COMMUNITY BOARD #1 – MANHATTAN
RESOLUTION

DATE: SEPTEMBER 25, 2018

RE: Manhattan Detention Complex

- Project Site
- Study Area Boundary (400-foot perimeter)
- Proposed Demapped Area

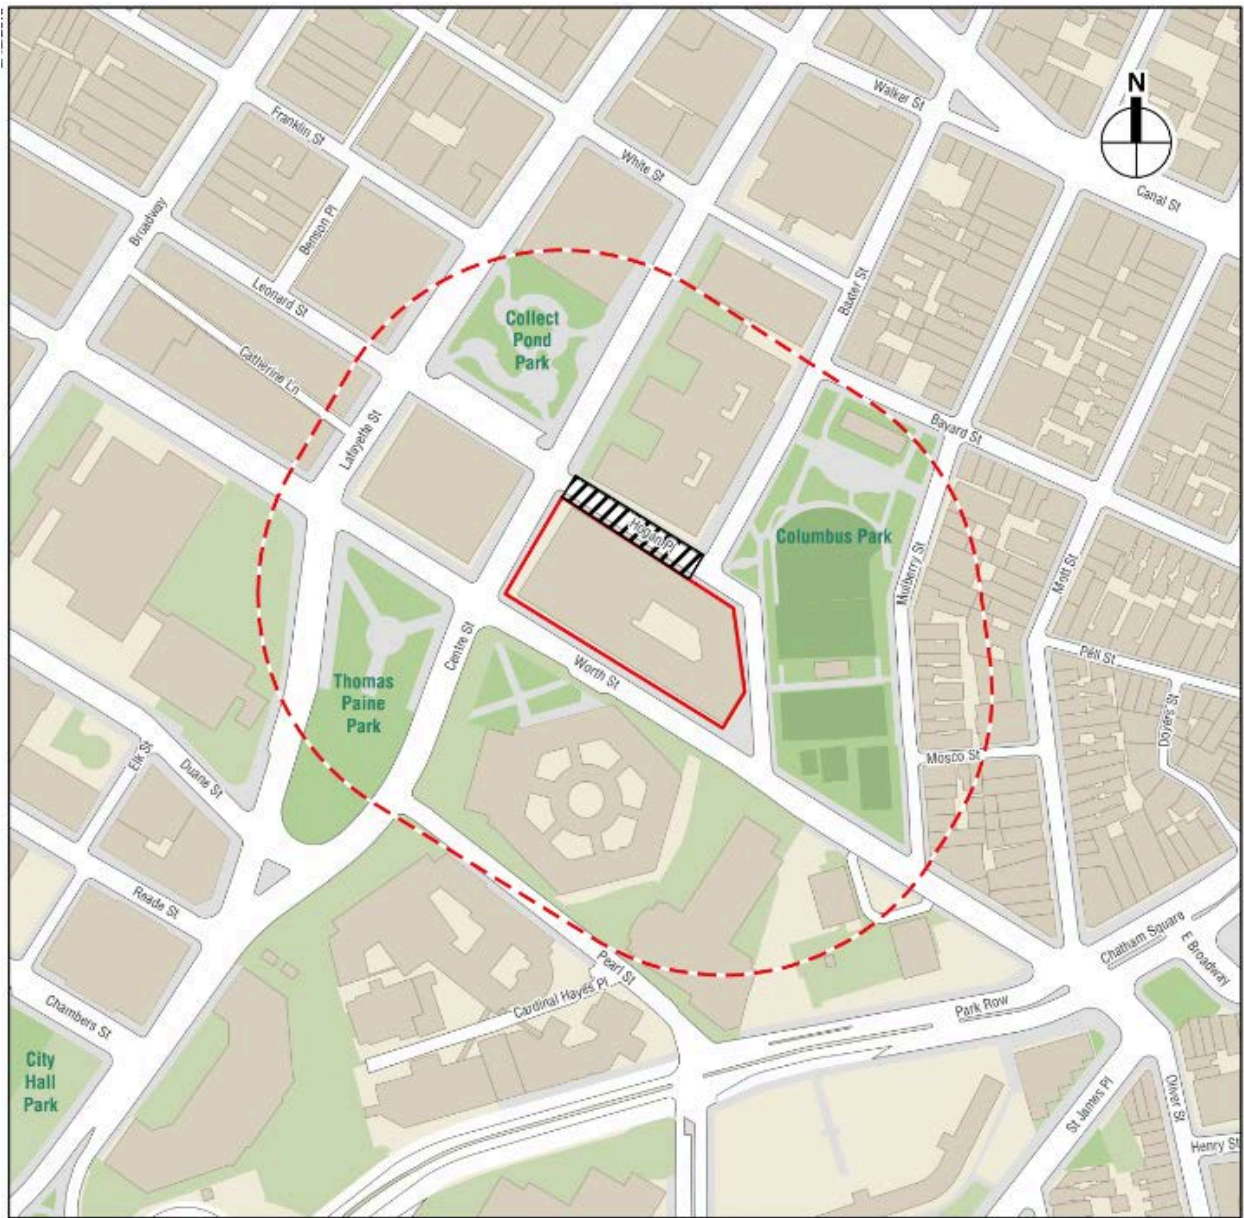
THAT: CB1 concludes that the study area contained in the DSOW (a mere 400 foot buffer around the site) is woefully inadequate and leads to minimizing or even missing impacts on the surrounding neighborhoods. CB1 would require that this be increased to at least a 1,200 foot buffer.
